Rezoning Transportation Analysis

Petition Number: 2020-124

General Location Identifier: Tax ID (07901504, 07901505)

Revision Log:

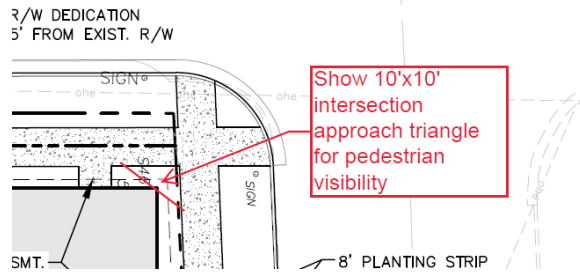
- ~~2. **Traffic Study** A Traffic Impact Study is not necessary for the complete review of this petition. If during the permitting process the site generates more than 2,500 daily trips, then a traffic study will be required.~~
- ~~3. Revise the site plan and conditional note(s) to commit to install two CLDSM and PROWAG standard accessible ramps at the Dunloe Street and Sylvania Avenue intersection location, shown below.~~

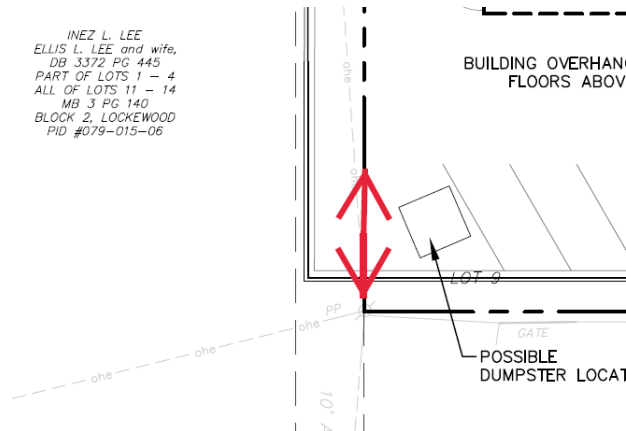
- ~~4. Revise the site plan and conditional note(s) to confirm the proposed building footprint does not encroach within the pedestrian approach intersection sight triangle, in conformance with CDOT's Sight Distance Policy. This triangle is measured from the back of the proposed sidewalk utility easement.~~

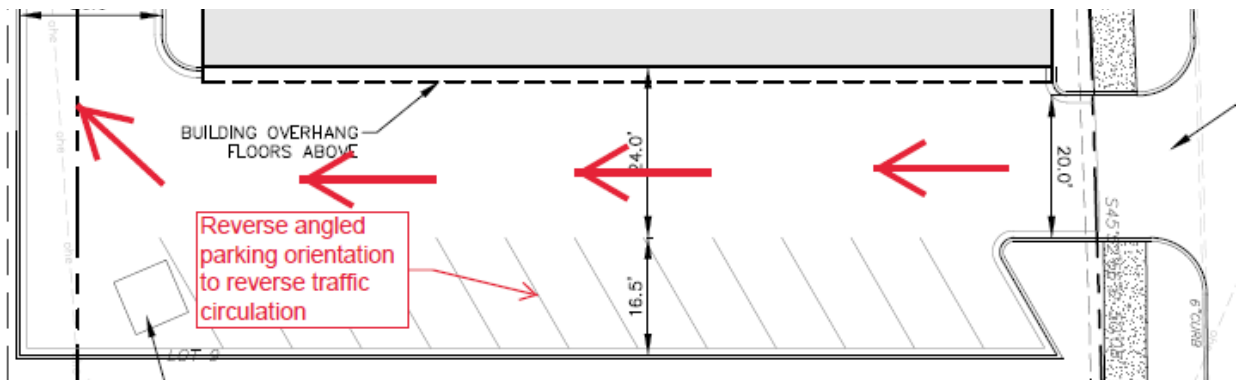
5. ~~Revise the site plan and conditional note(s) to provide a stub for future cross access within the existing alleyway.~~
